Access Compliance Report

Public Rights-of-Way

(Curb Ramps)

Intersection ID: 43669	Main Street: CORSICA_FOREST_DR	Cross Street: ASHETON_CREEK_DR	Location: NE
ADA ID: 75FFE19852B6	Ramp Type: PerpDiag	Initial Pass/Fail: Fail	Overall Compliance: No
Severity Score: 8.75			
Codes/Mitigation Info/Possible Solution		Field Measurements/Component Compliance

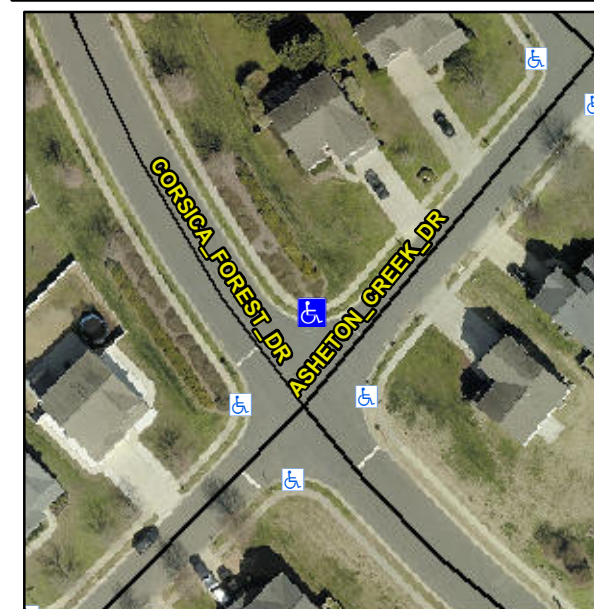
Not Found, R304.5.1

Compliance	Description	Data	Compliance	Description	Data
N/A	Ramp Length (in)	47.0	Yes	Ramp Slope (%)	5.8
No	Ramp Width (in)	40.0	Yes	Ramp XSlope (%)	0.5
N/A	Flare Type LT	N/A	N/A	Flare Type RT	N/A
N/A	Flare Slope LT (%)	N/A	N/A	Flare Slope RT (%)	N/A
N/A	Flare Traversable LT?	N/A	N/A	Flare Traversable RT?	N/A
N/A	Landing Length (in)	N/A	N/A	DWS Provided?	N/A
N/A	Landing Width (in)	N/A	N/A	DWS Contrast?	N/A
N/A	Landing Slope (%)	N/A	N/A	DWS Length (in)	N/A
N/A	Landing X Slope (%)	N/A	N/A	DWS Full Width?	N/A
N/A	Landing Curb? (Y/N)	N/A	N/A	DWS Offset (in)	N/A
N/A	Shared Landing?	N/A			
N/A	Gutter Ponding?	N/A	N/A	Gutter Slope (%)	N/A
N/A	Gutter Lip Ht (in)	N/A	N/A	Gutter X Slope (%)	N/A
N/A	Painted X Walk1?	No	N/A	Painted X Walk2?	No
	X Walk 1 Direction	To SW		X Walk 2 Direction	To SE
N/A	X Walk 1 Width (in)	N/A	N/A	X Walk 2 Width (in)	N/A
	X Walk 1 Slope (%)	3.0		X Walk 2 Slope (%)	6.7
	X Walk 1 X Slope (%)	5.4		X Walk 2 X Slope (%)	1.3

N/A	Ramp inside XWalk1?	N/A	N/A	Ramp inside XWalk2?	N/A
	Road Slope (%)	1.1	N/A	Clear Space?	N/A
	Road X Slope (%)	7.8	N/A	Clear Space to XWalk (in)	N/A
N/A	Any Obstructions?	N/A	N/A	Storm Grate/Utility Hazard?	N/A
	Obstruction Type			Storm Grate/Utility Type	
		N/A			N/A
			Yes	Surface Condition? (G/P)	Good

Remove & Replace Curb Ramp With Two New Directional Ramps or Equivalent.
